FOR PUBLIC  
HEARING  
PETITION No.  
2005

Project #  
**Renovations for  
SKYERS CHILD  
DEVELOPMENT CENTER**  
7023 Beatties Ford rd  
Charlotte, North Carolina

Sheet Description #  
**SITE PLAN  
PROPOSED REZONING**

SITE PLAN  
SCALE = 1" = 40'-0"

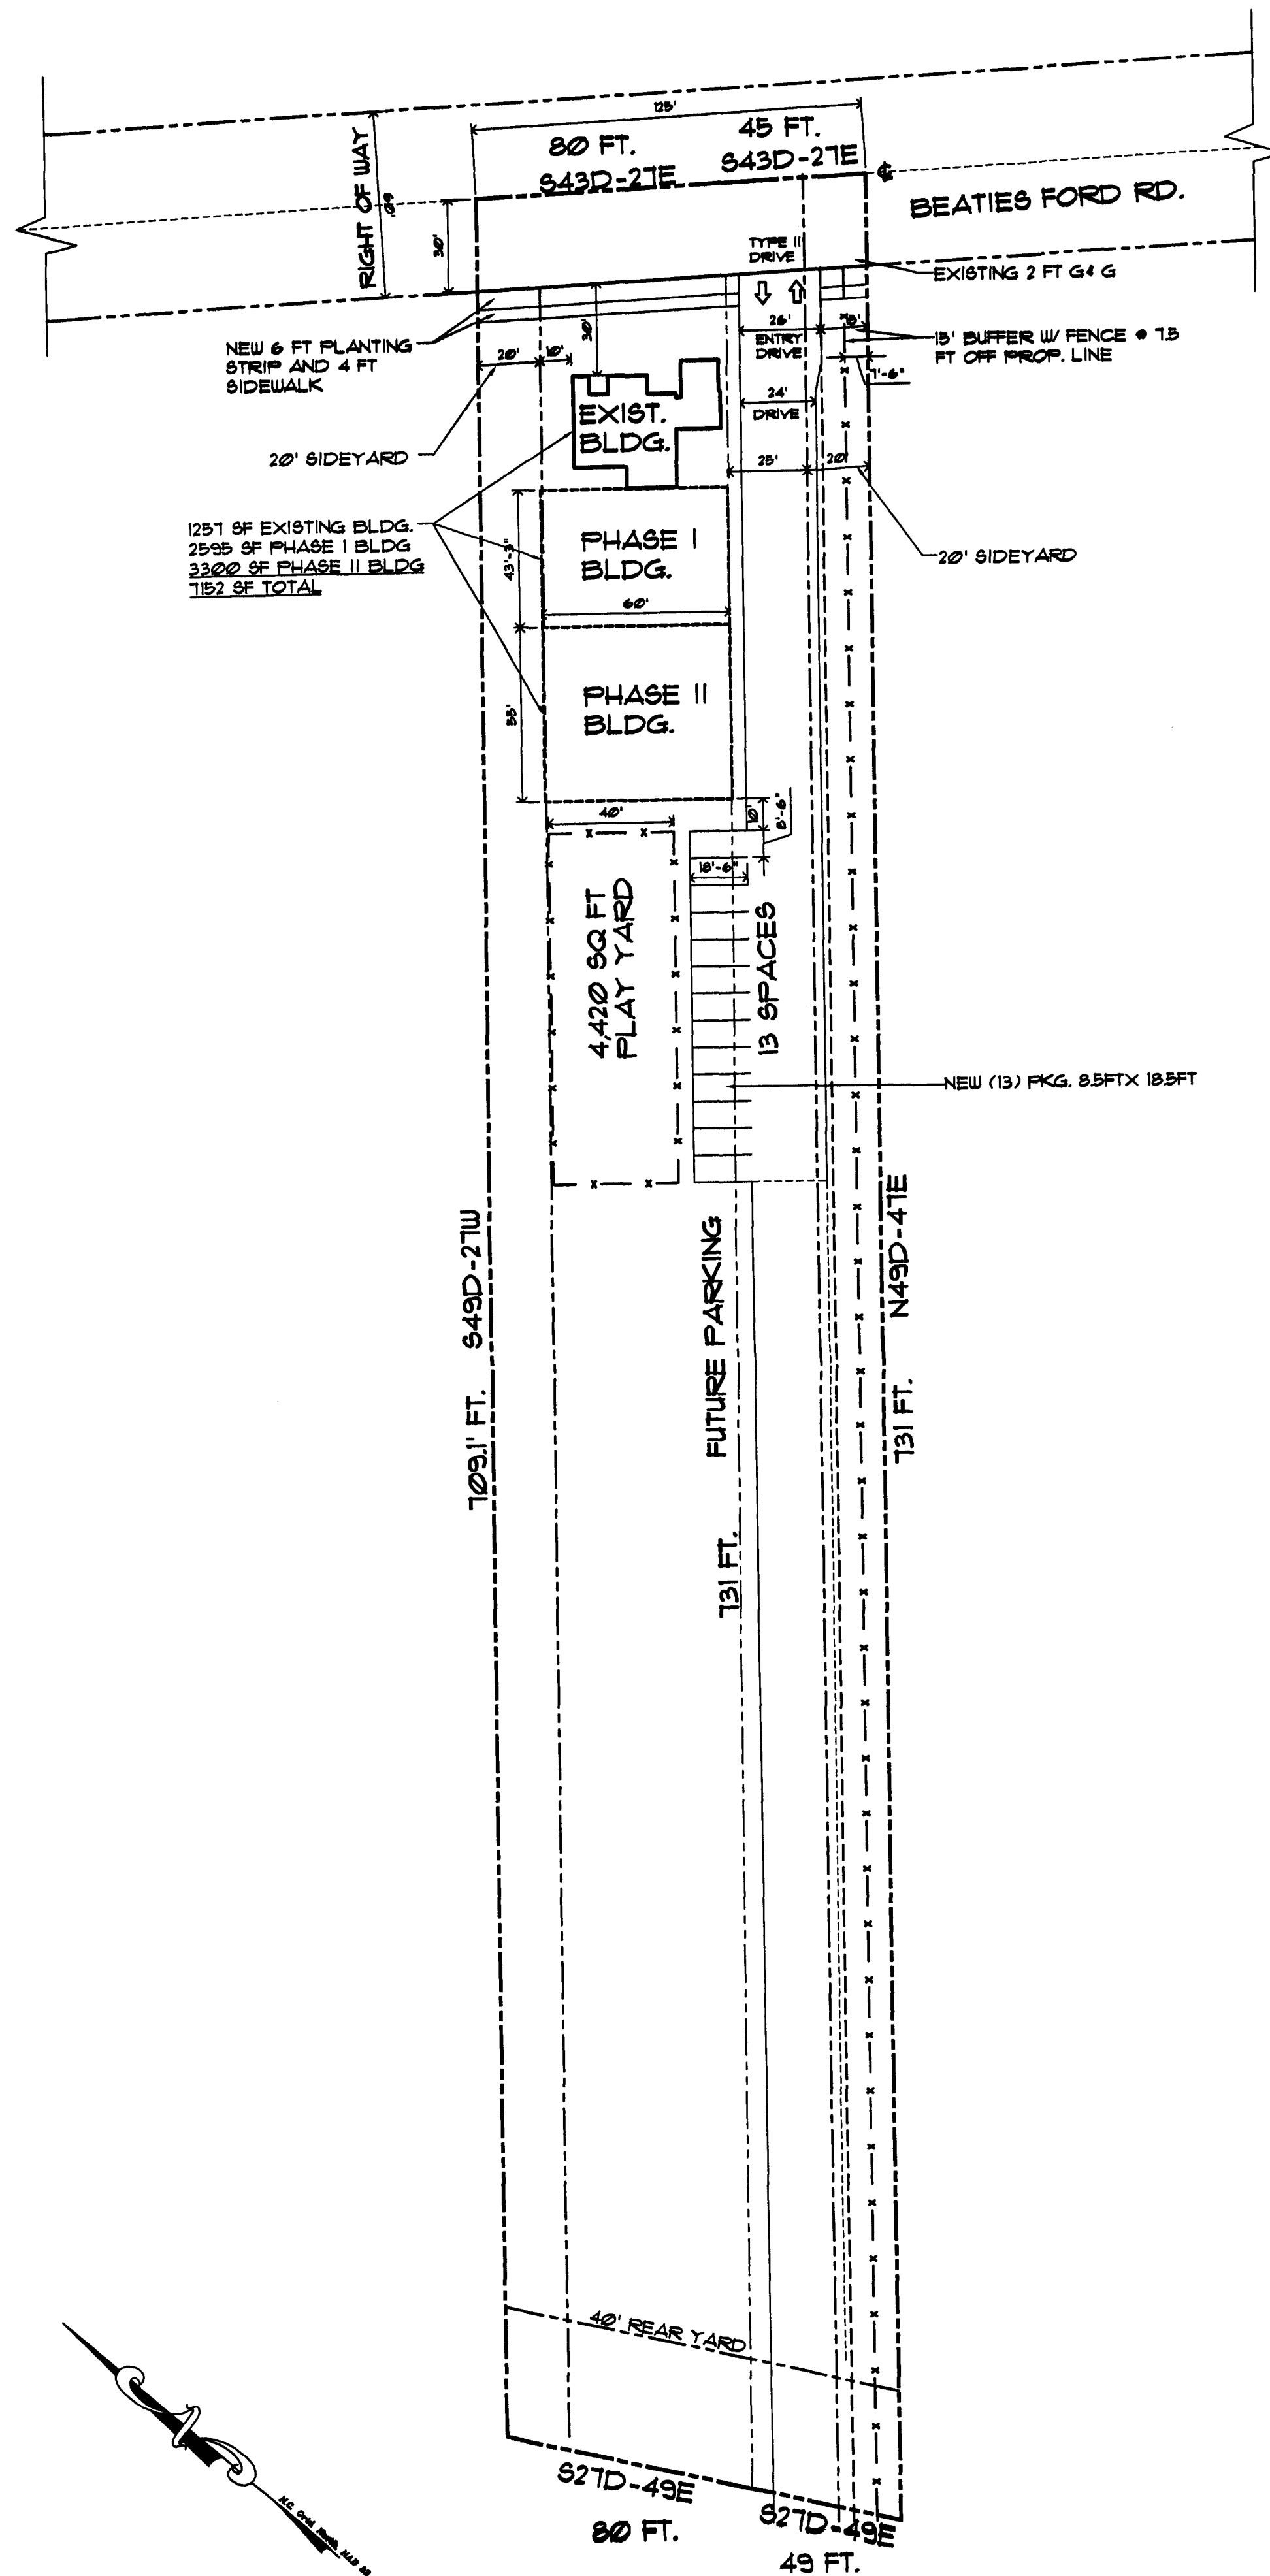
PLANNING COMMISSION NOTES/ RESPONSES:  
DRIVEWAY TYPE, WIDTH AND LOCATION TO BE DETERMINED BY CDOT.  
ANY FENCE OR DRIVEWAY CONSTRUCTED ALONG OR ADJACENT TO ANY SIDEWALK OR STREET RIGHT-OF-WAY REQUIRES A CERTIFICATE ISSUED BY CDOT.  
NEW RECONSTRUCTED DRIVEWAYS MUST BE DROP CURB RAMP TYPE II DRIVEWAYS.  
LOCATIONS AND WIDTHS OF ALL ADJACENT AND OPPOSING DRIVEWAYS ARE SHOWN.  
TYP. PARKING MODULE IS 8'-6" X 18'-6"  
PARKING SUMMARY IS LISTED UNDER "DESIGN GUIDELINES" ITEM "B" "OFF STREET PARKING"  
"THE PETITIONER ACKNOWLEDGES THAT OTHER STANDARD DEVELOPMENT REQUIREMENTS IMPOSED BY OTHER CITY ORDINANCES, SUCH AS THOSE THAT REGULATE STREETS, SIDEWALKS, AND SITE DEVELOPMENT, MAY APPLY TO THE DEVELOPMENT SITE. UNLESS SPECIFICALLY NOTED IN THE CONDITIONS FOR THIS SITE PLAN, THESE OTHER ADDITIONAL STANDARD DEVELOPMENT REQUIREMENTS WILL BE APPLIED TO THE DEVELOPMENT OF THIS SITE AS DEFINED BY THOSE OTHER CITY ORDINANCES"
